AGENDA PORTLAND PLANNING BOARD MEETING

The Portland Planning Board will hold a meeting on April 23, 2019, Council Chambers, 2nd Floor, City Hall, 389 Congress Street. **Public comments will be taken for each item on the agenda during the estimated allotted time and written comments should be submitted to planningboard@portlandmaine.gov.**

To: Sean Dundon, Chair, and Members of the Portland Planning Board
From: Matthew Grooms, Planner
Date: April 19, 2019
Re: WCZ Text Amendment – Prohibit Contract and Conditional Rezoning
Meeting Date: April 23, 2019

SK-1

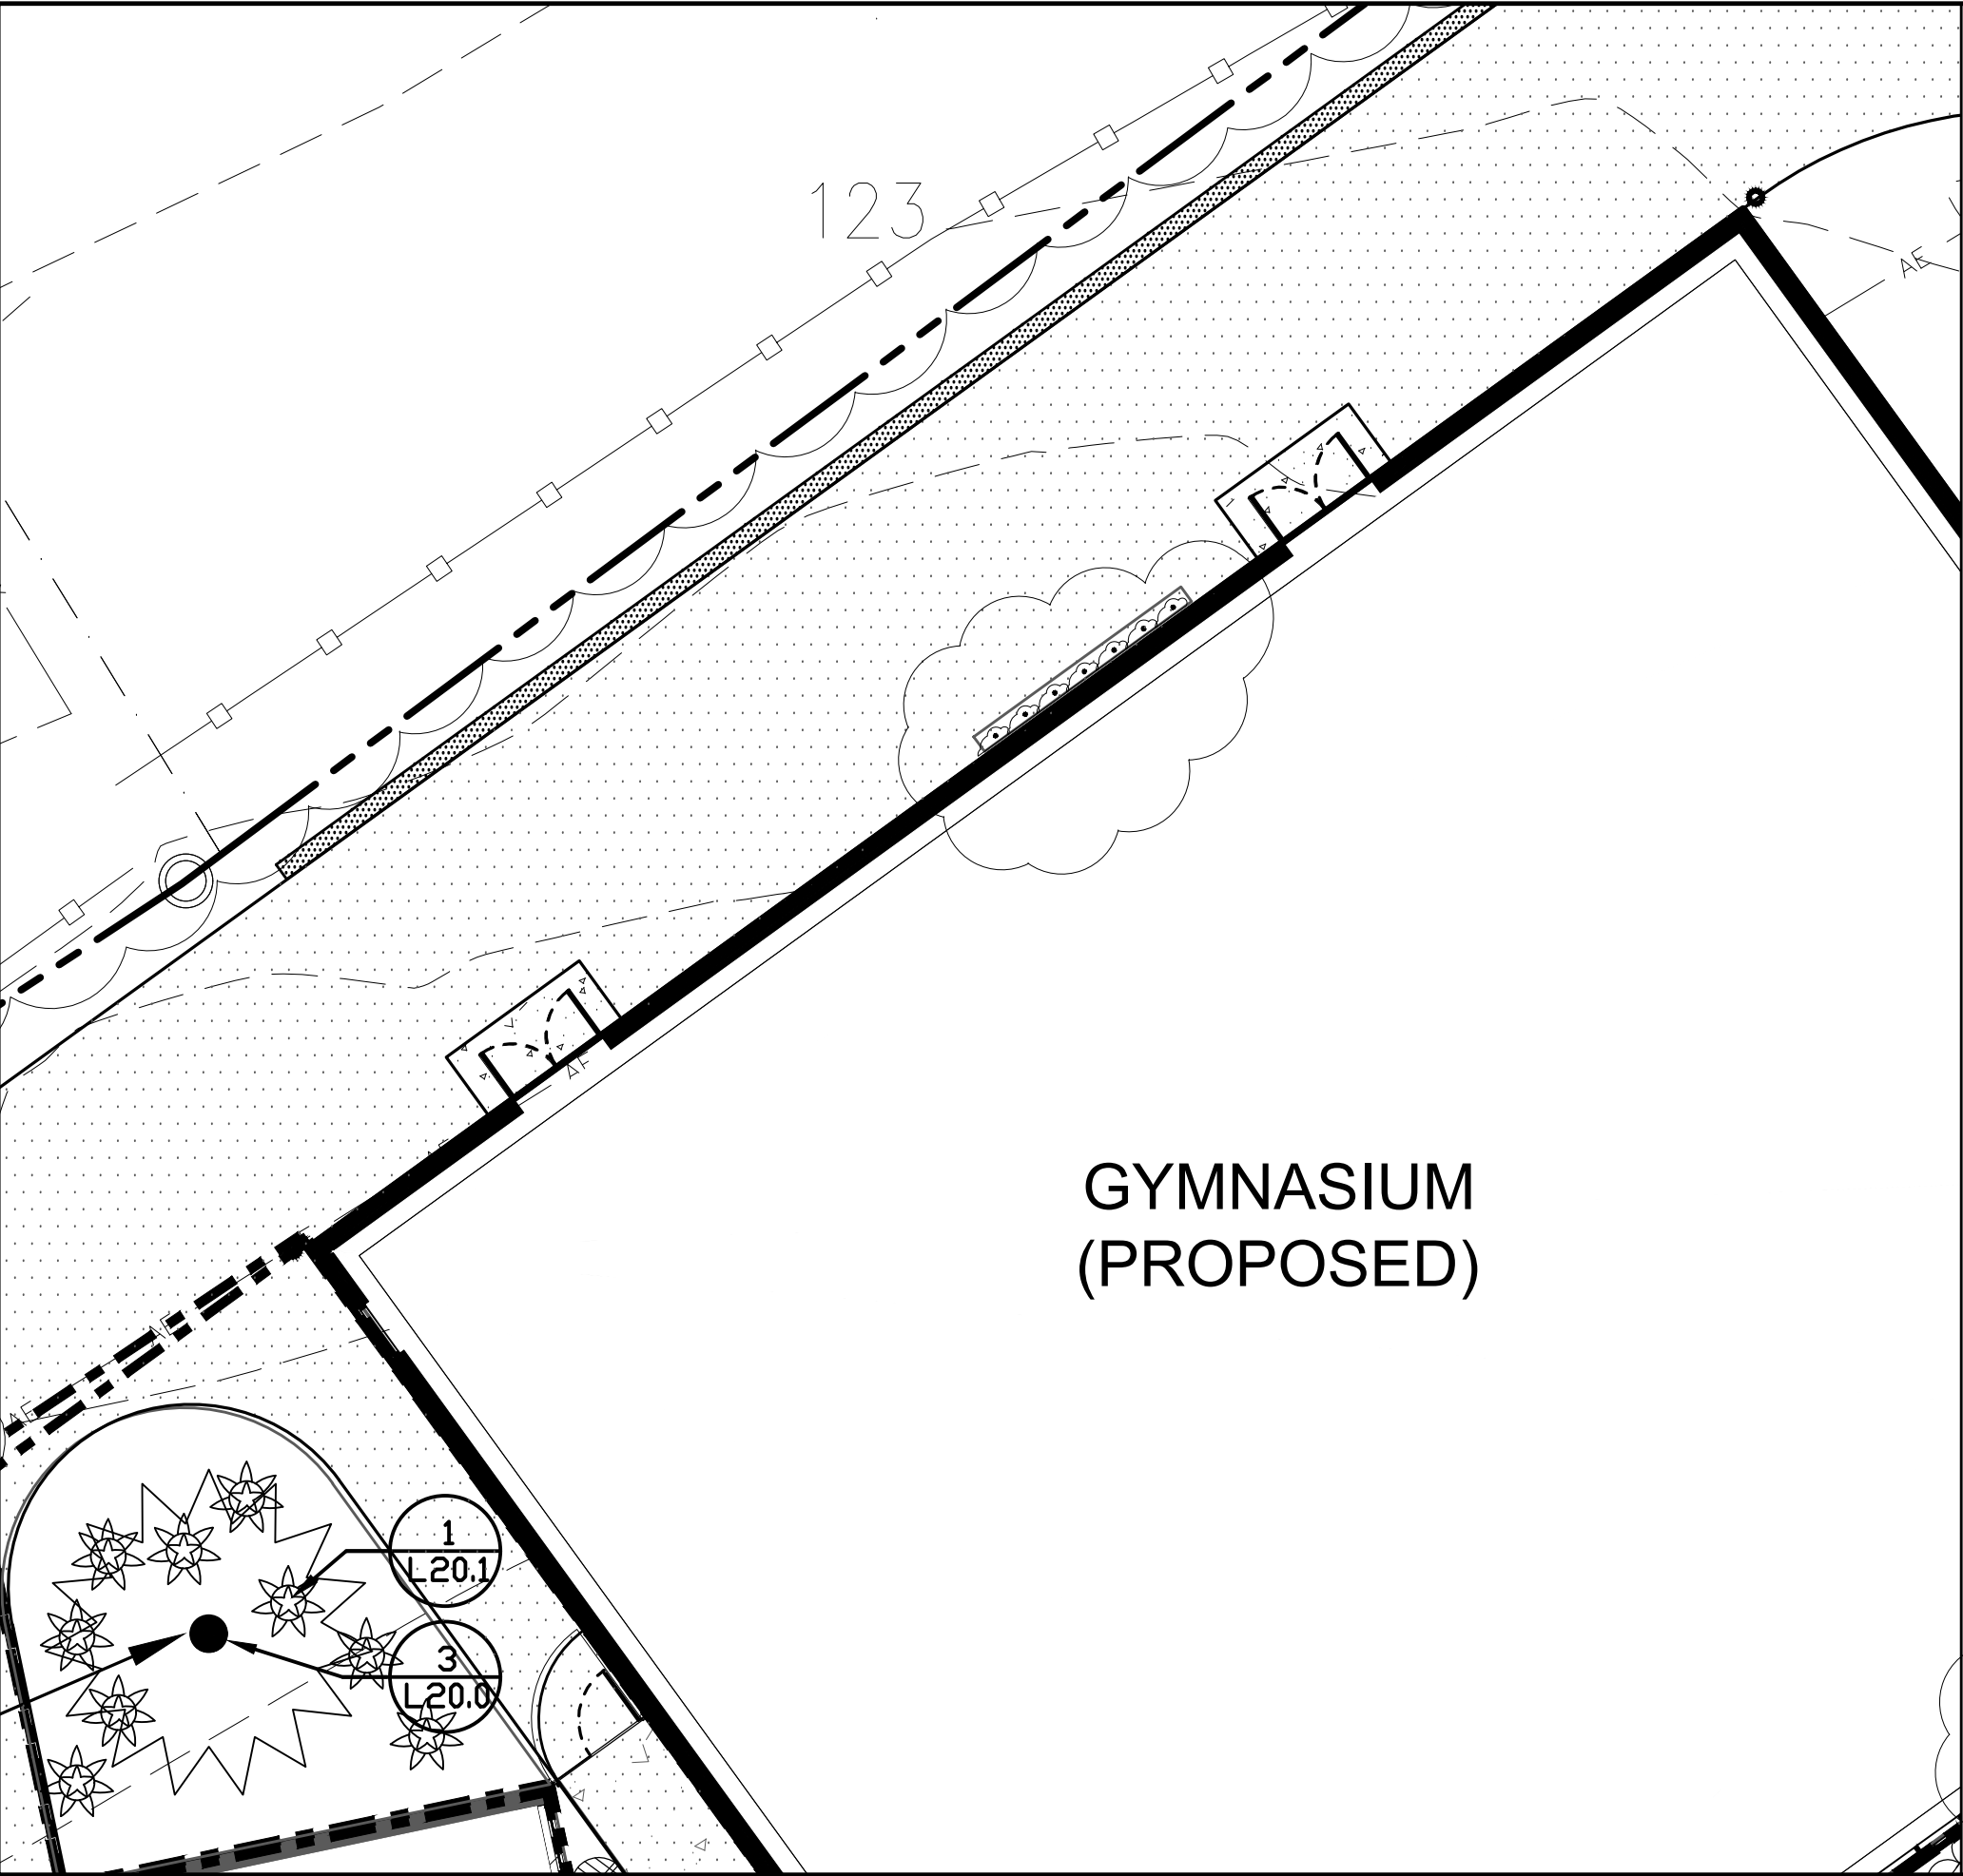
4. *North Fire Lane: Can a fire truck turn from the parent drop-off aisle into the fire lane?*
Yes, a full-size fire truck can turn from the parent drop-off bypass aisle into the gated fire lane, by driving over a small section of concrete pavers, which have recently been added to the Site Plan C00.1. A ‘North Fire Truck Access Turning Template’ drawing has also been included to show the turning movement for the Portland fire truck.

DRAWING NO.
C-10

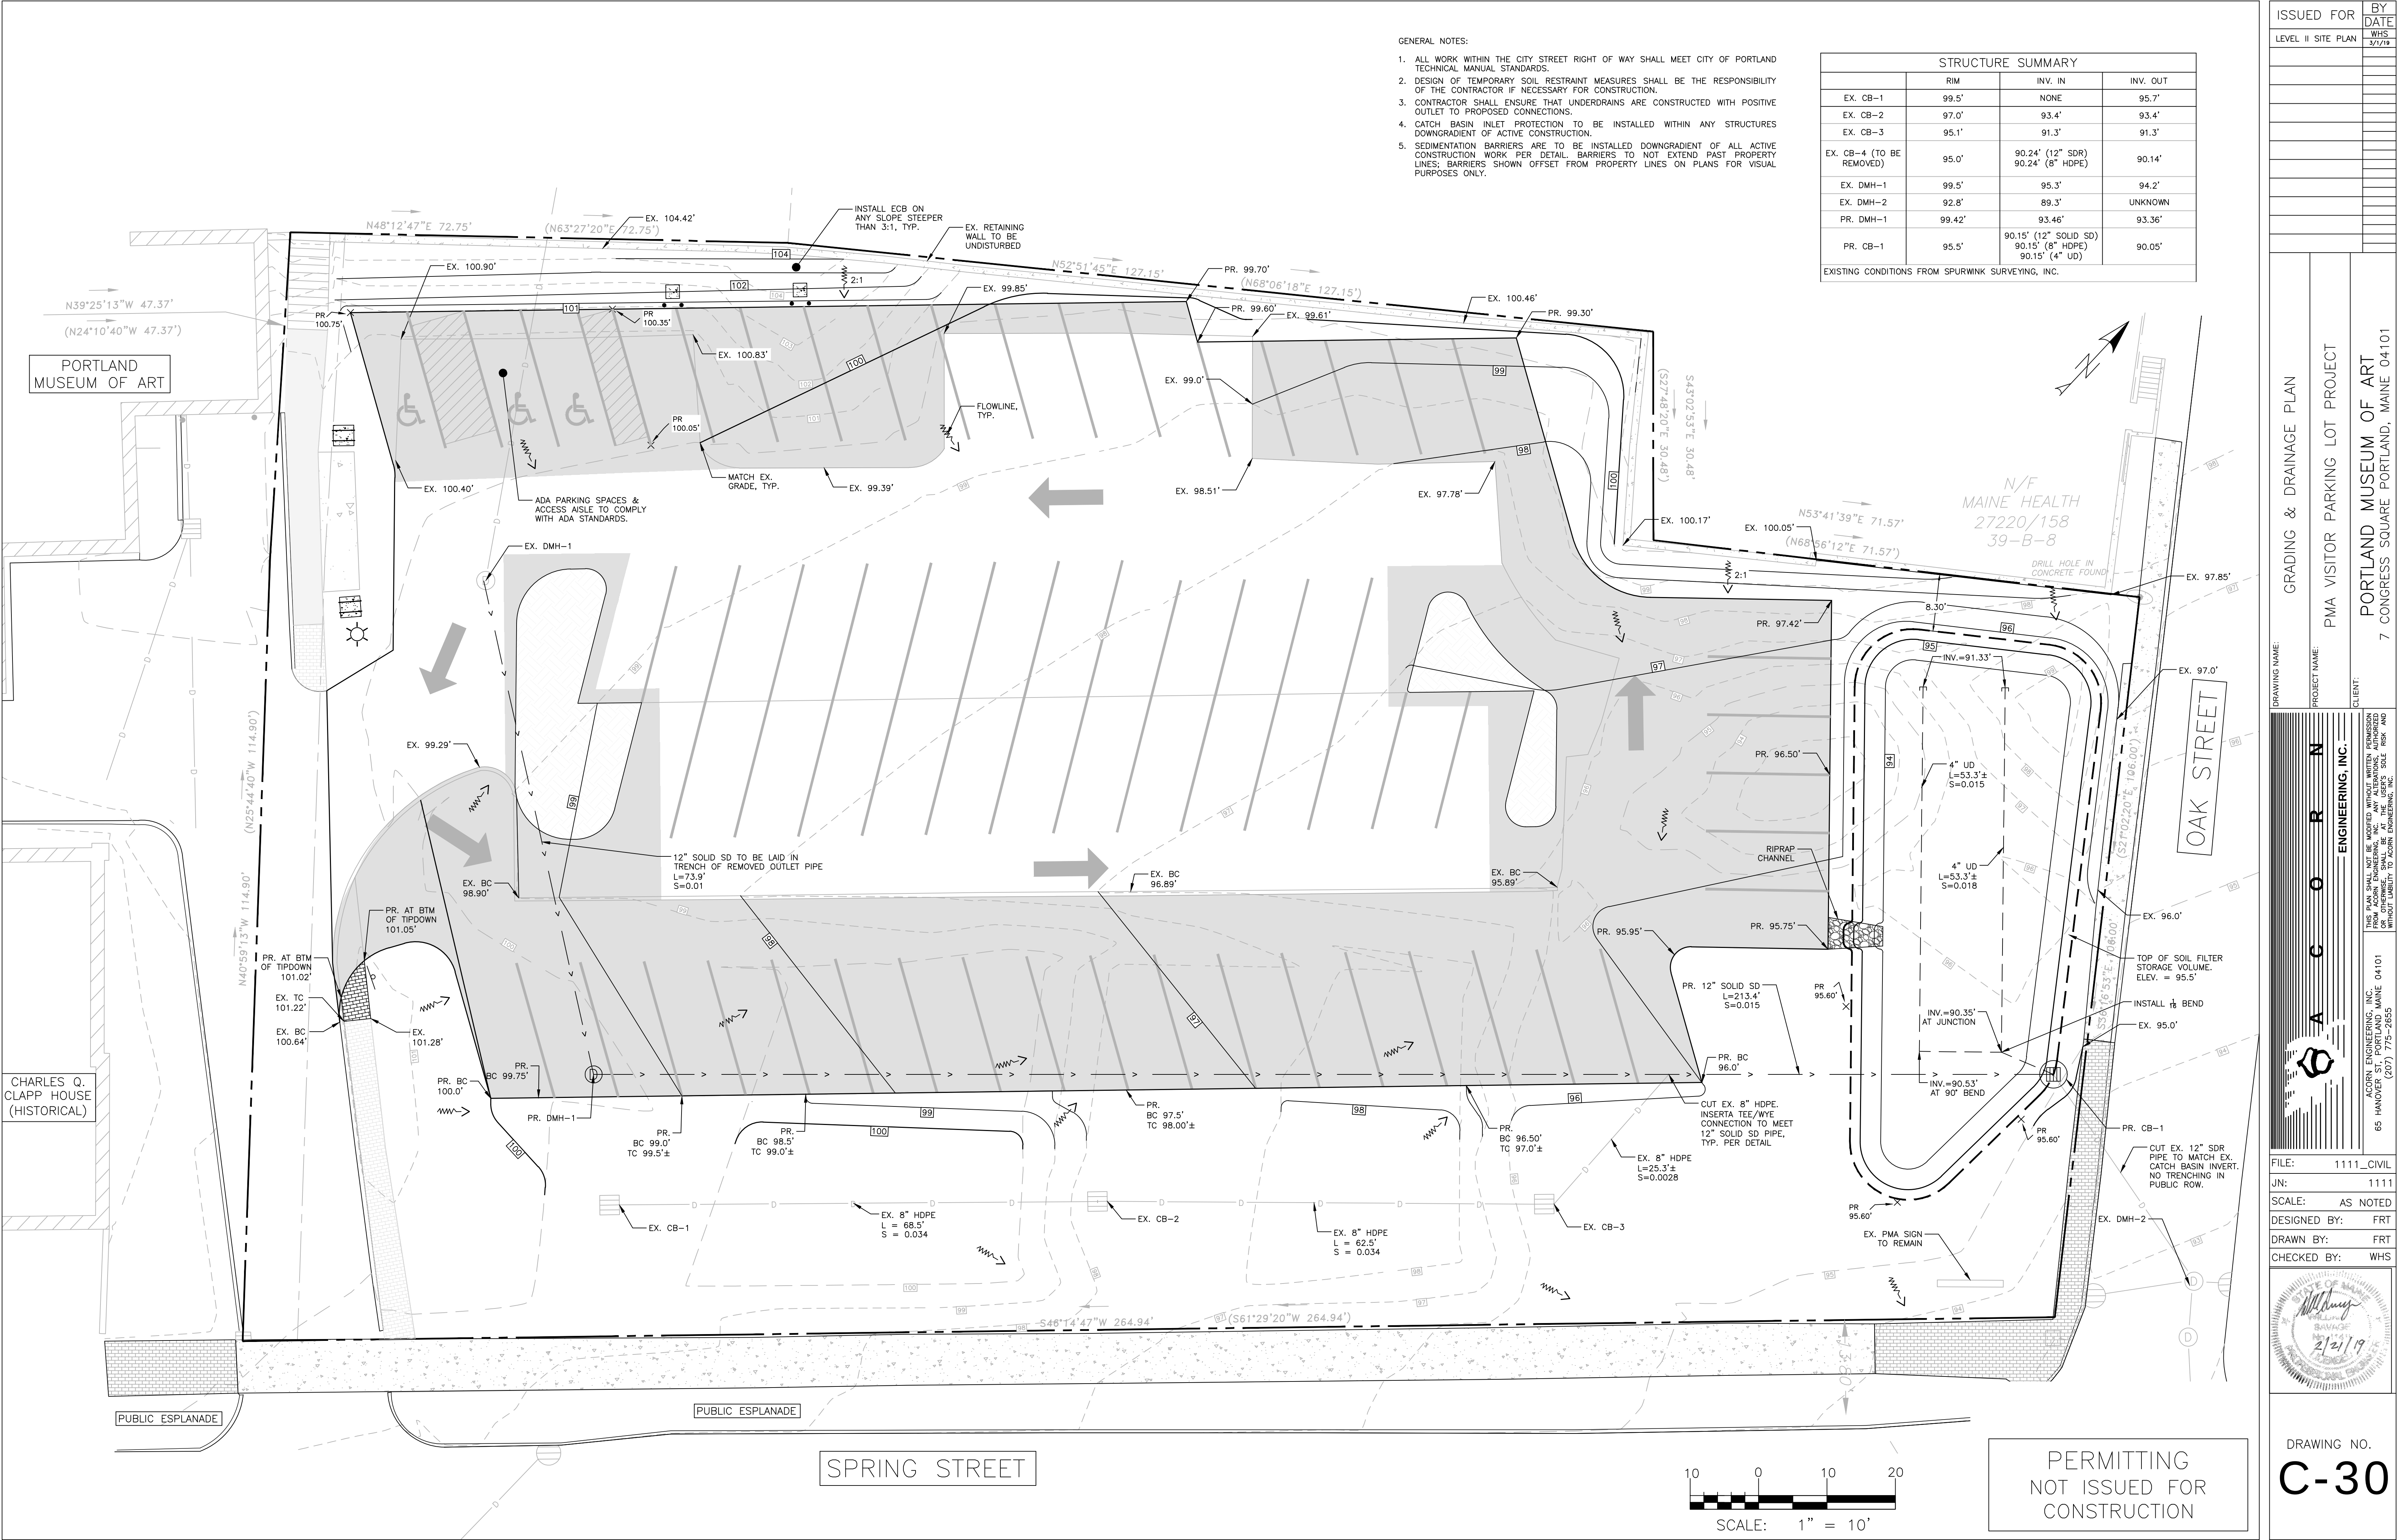
Comment 2: The parking spaces proposed are shown as 75-degree spaces with an 18-foot drive aisle and standard lengths and widths. The City's technical standards do not provide a detail for 75-degree parking spaces; we have details for 30-, 45-, 60-, and 90-degree spaces. The drive aisle width is potentially problematic for 75-degree spaces. The City's technical standards require 19-foot drive aisles for 60-degree spaces; in general, the greater the angle of parking spaces, the less drive aisle space is needed, so 75-degree spaces would typically require a drive aisle greater than 19 feet. Several online resources indicate that the appropriate aisle width for 75-degree spaces are in the range of 20-22 feet.

The initial proposal did not meet the street tree standard along Spring Street. The applicant responded to review comments and added two additional street trees along Spring Street to meet 4.6.3 of the Technical Manual, as shown on the attached Site Plan, Sheet C-10. The revised plan meets the Landscaping and Landscape Preservation Standards.
